# City of Santa Fe

Land Use Department | Historic Preservation Division

**Plan Number:** 2023-007678--HDRB

**DATE:** March 26, 2024  
**TO:** Historic Districts Review Board Members  
**FROM:** Lani McCulley, Senior Planner, Historic Preservation Division

Exception to Section 14-5.2(D)(5)(a): The applicant requests an exception to alter openings on a primary façade by infilling and replacing windows and doors.

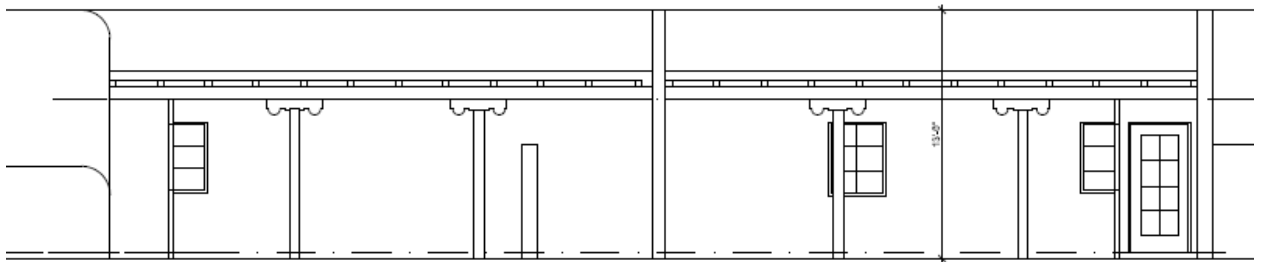
Staff Response: Staff agrees that this residential structure, which is one of the three located in the Plaza del Monte compound, has changed use from a multi-family unit to a single-family unit and this makes the need for the multiple entries obsolete. The overall design of the structure is not being altered so it will not damage the character of the district or neighborhood to alter the fenestrations to meet the current use of the structure.

Staff Response: Staff agrees that this residential structure, which is one of the three located in the Plaza del Monte compound, has changed use from a multi-family unit to a single-family unit and this makes the need for the multiple entries obsolete. The overall design of the structure is not being altered so making it more compatible with the current use will prevent complications for the family that lives in it.

Staff Response: Staff agrees that as a single-family unit the single door and other opening changes are compatible with the design options for the interior remodel of the structure and blend in with the rest of the compound. The applicant did consider closing off the unnecessary openings on the interior only of the structure; however, this did not accomplish removal of confusion for what constitutes as the entrance to the single-family residence.

SHEET TITLE:  
**126 CAMINO SANTIAGO  
EXISTING &  
PROPOSED  
SOUTH & WEST  
ELEVATIONS**

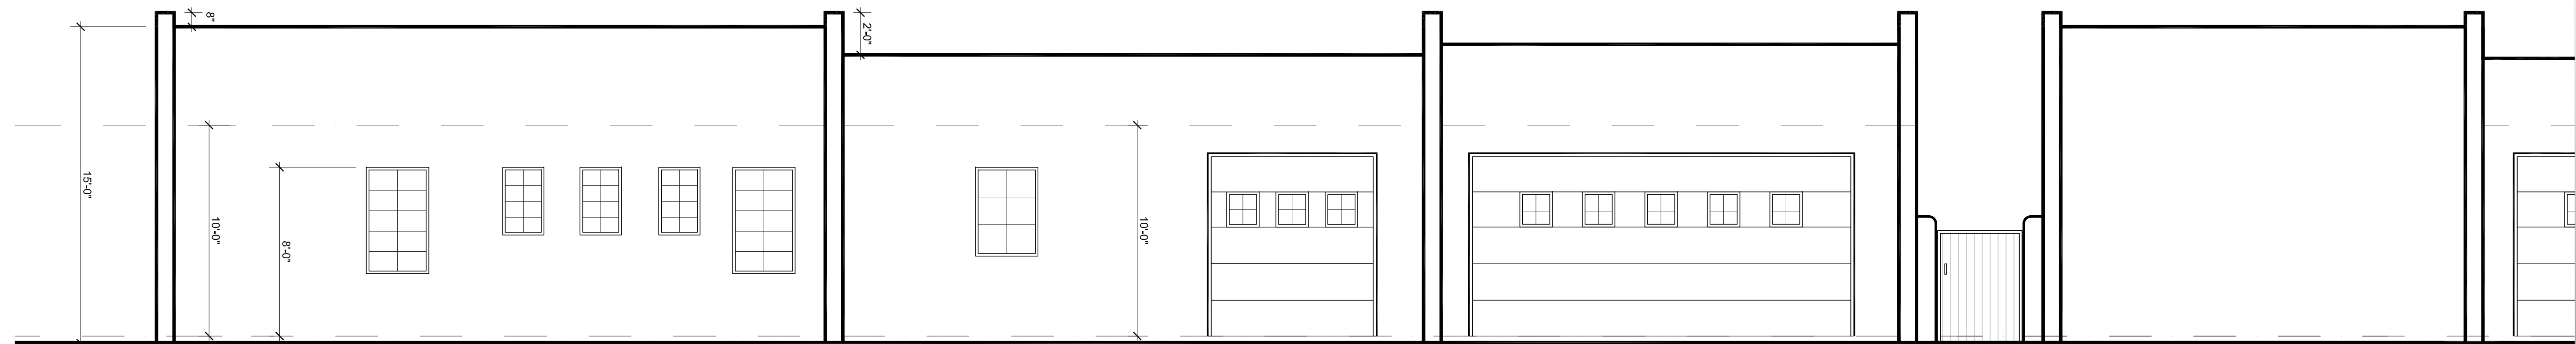
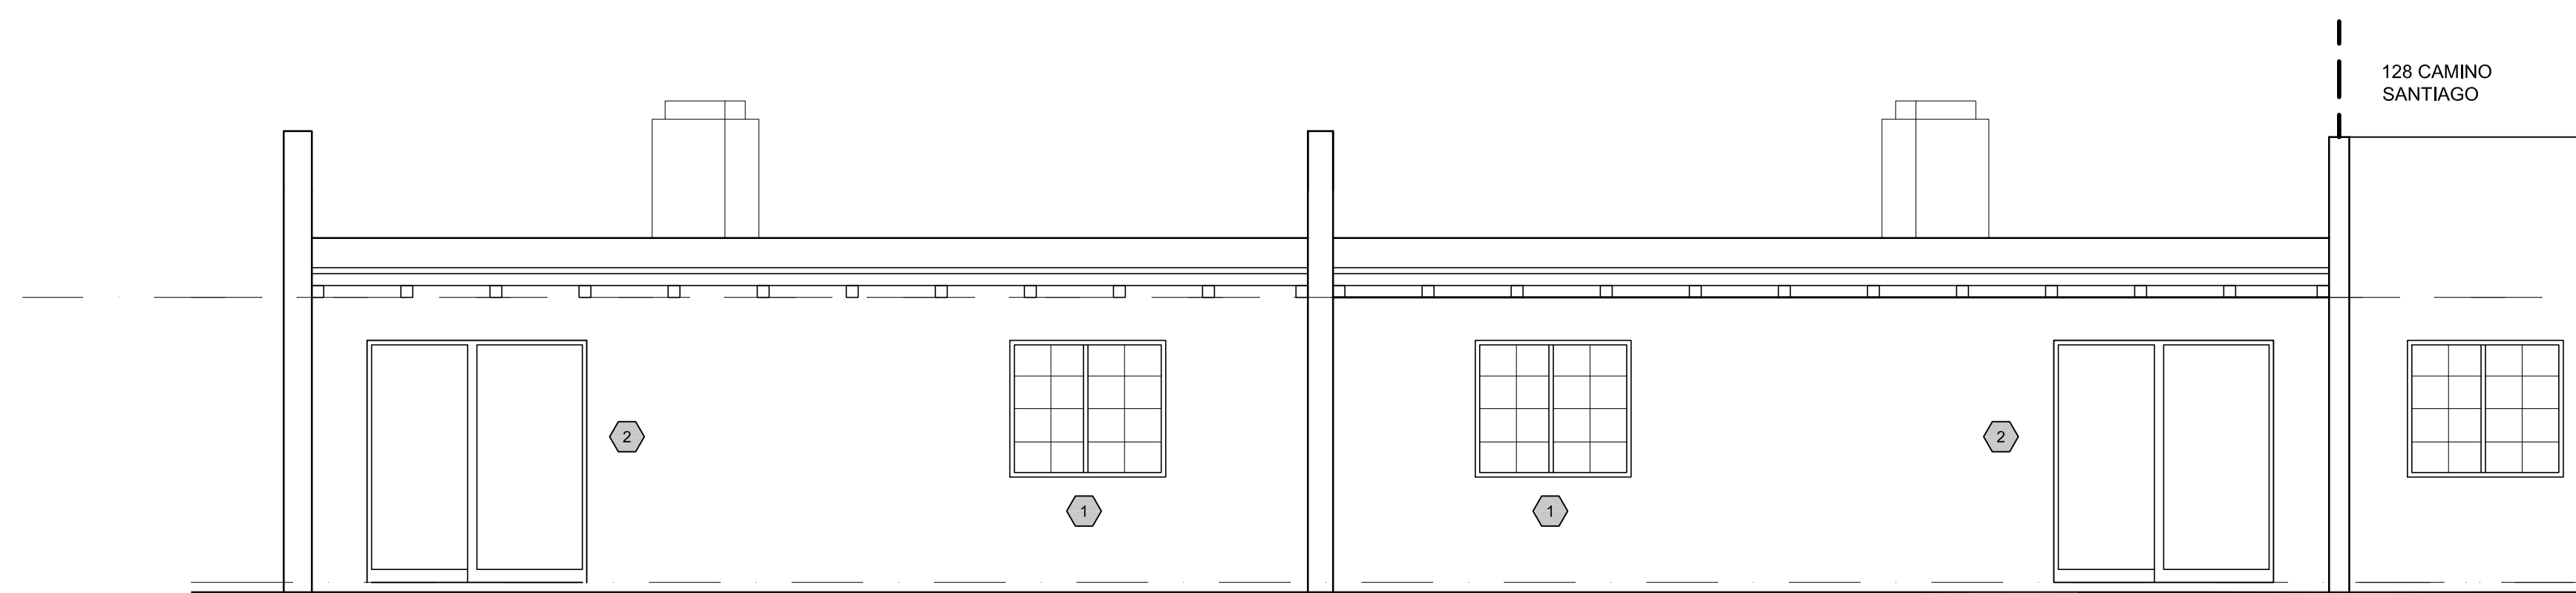
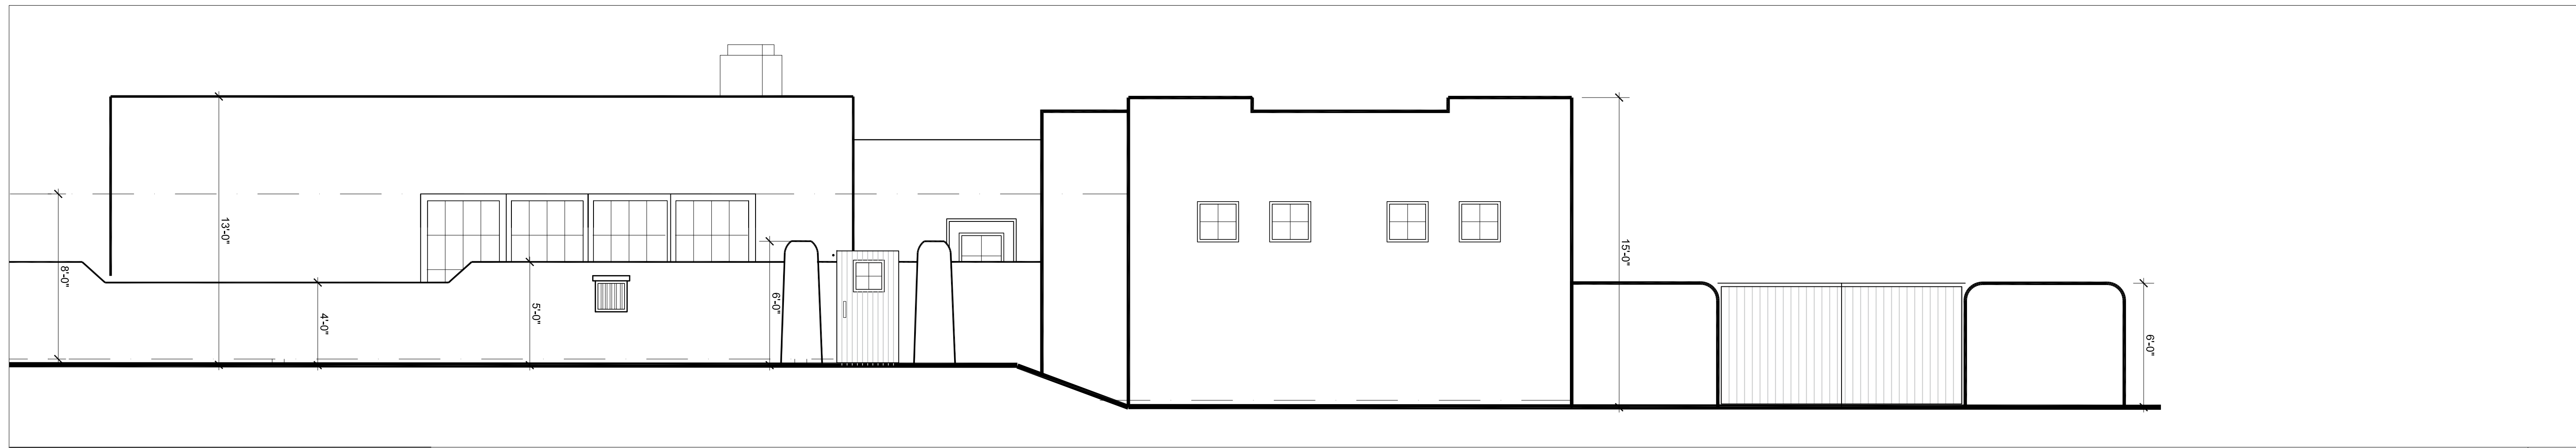
Designed garages with varying heights for each section to break up the parapet line.

Designed the garage with party walls to break up the singular parapet and mimic the party walls of the residence.

Set the garage doors further back in the door opening to create a shadowing effect.

The south elevation of the garages sees the introduction of a vertical element that reflects the original building design for the walls that serve as separations for the original building units. The parapets have been set at varying heights to provide a break-up of their lines along the south façade.
